MIL-M-28787/333
AMENDMENT 2
16 December 1992
SUPERSEDING
AMENDMENT 1
6 October 1983

MILITARY SPECIFICATION

MODULES, STANDARD ELECTRONIC

CONVERTER, D/A, KEY CODE MKR

FIGURE 6. Input clamp diode voltage (negative) test circuit for table V.

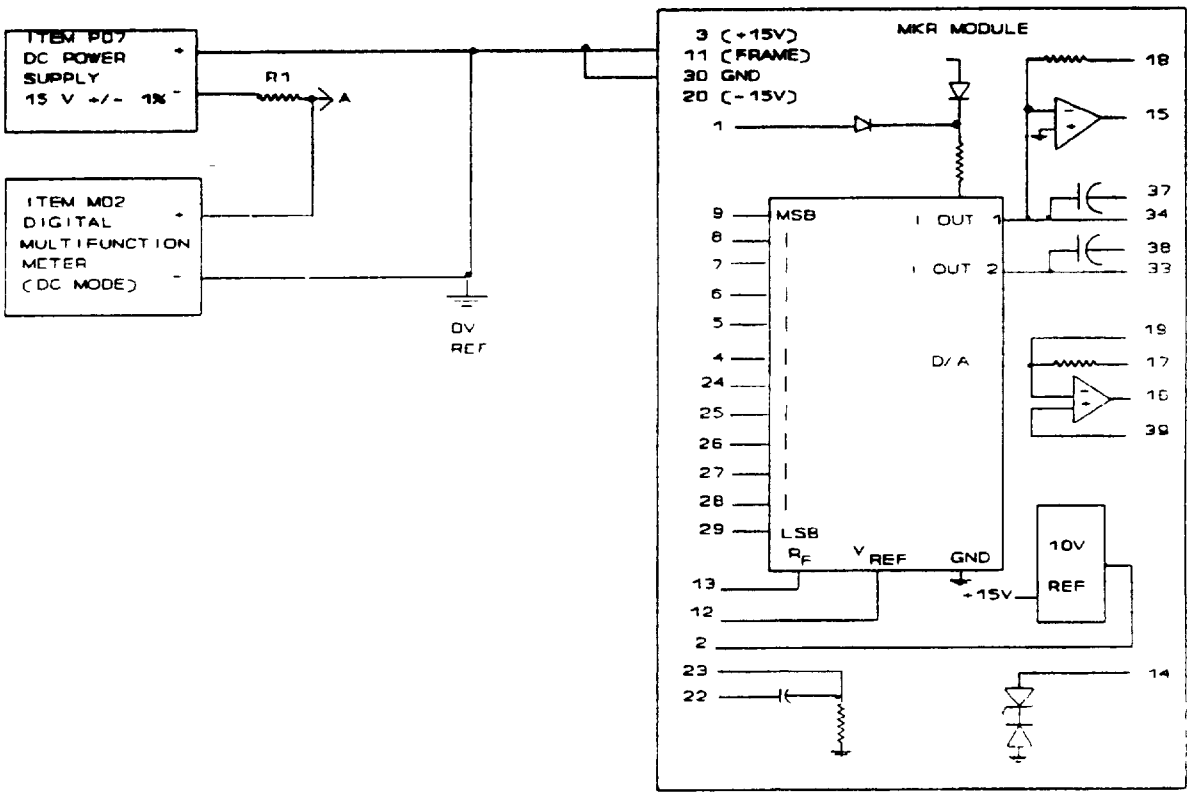
FIGURE 6: Delete and substitute new figure 6 as printed on page 4 of this amendment.

FIGURE 16. Gain frequency response check and distortion test circuit for tables XVI and XVII.

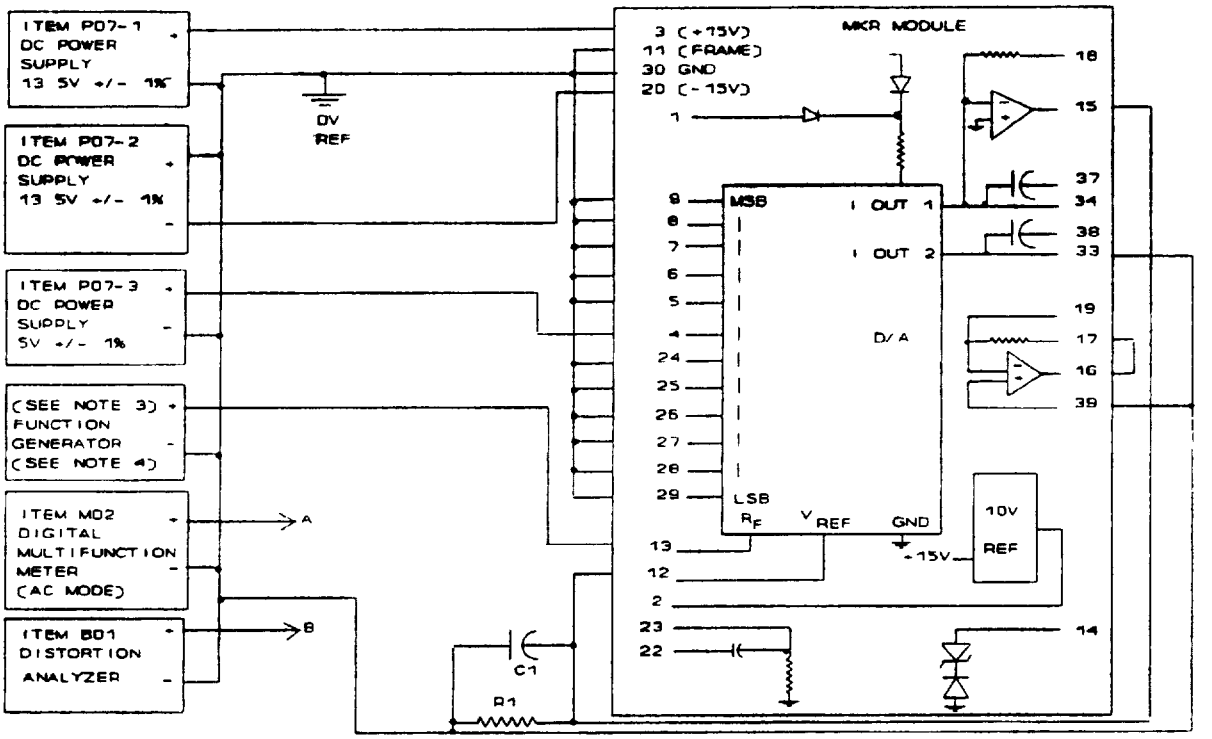
FIGURE 16: Delete and substitute new figure 16 as printed on page 5 of this amendment.

FIGURE 19. Settling time (t_{SHL} and t_{SLH}) test circuit waveforms for table XIX.

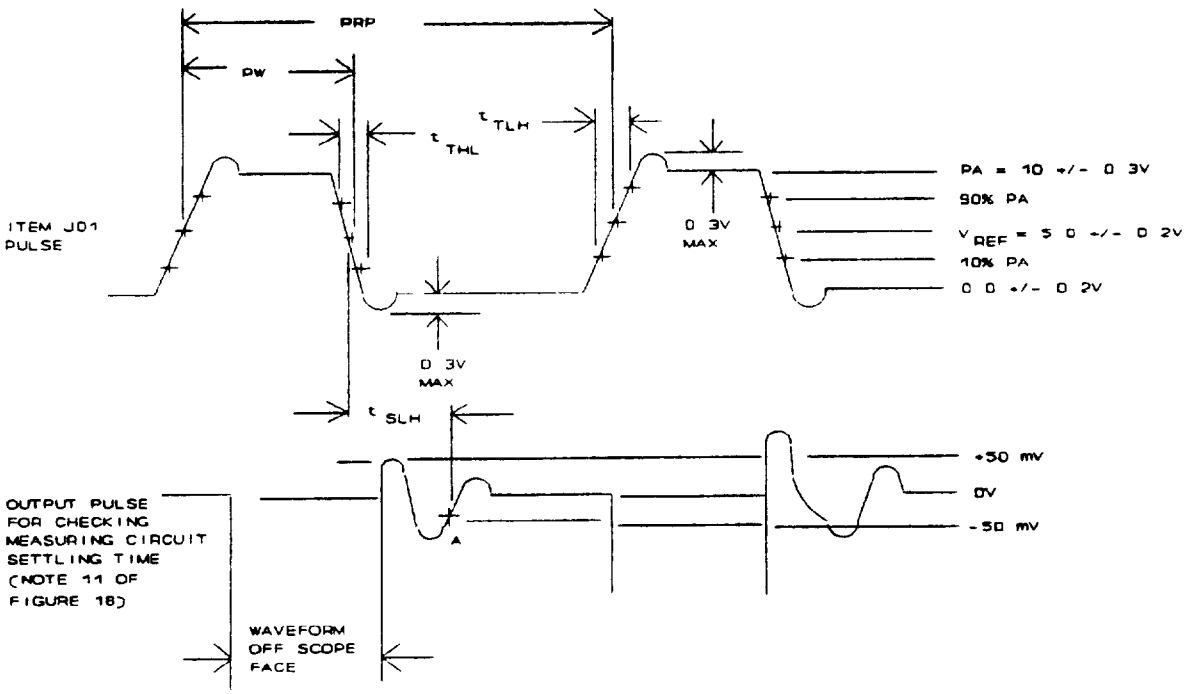
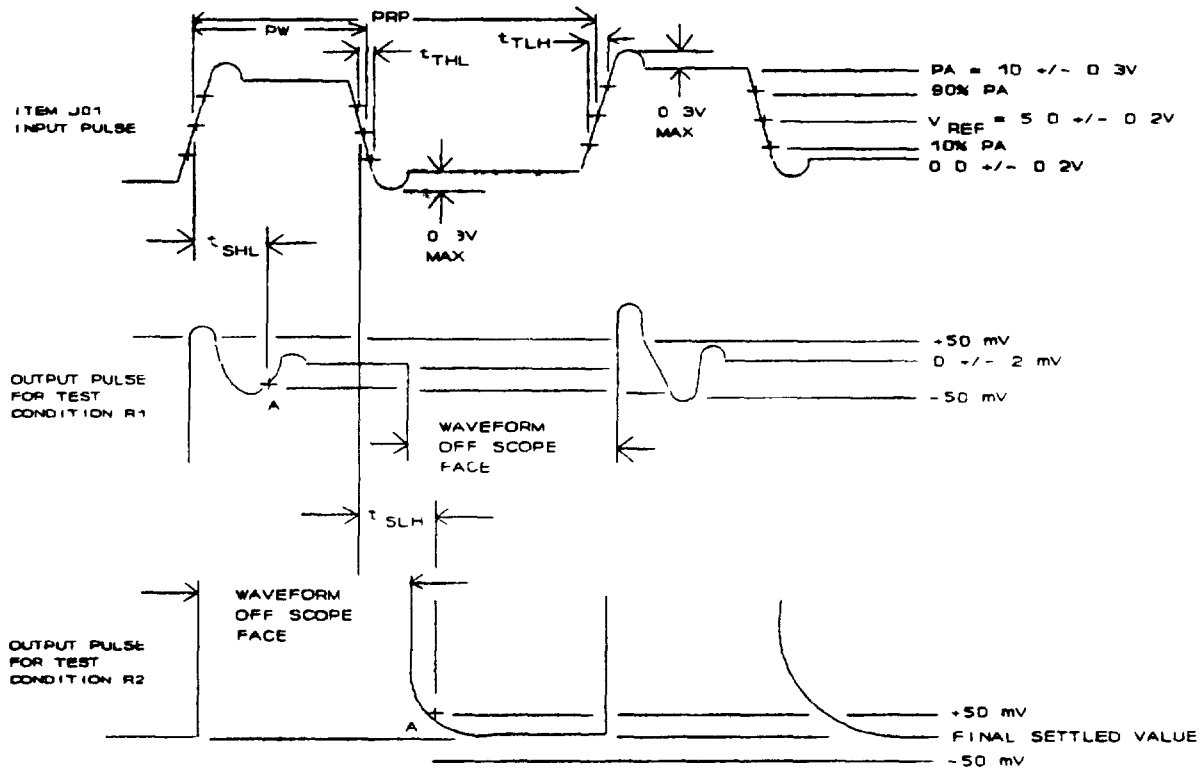
FIGURE 19: Delete and substitute new figure 19 as printed on pages 6 and 7 of this amendment.
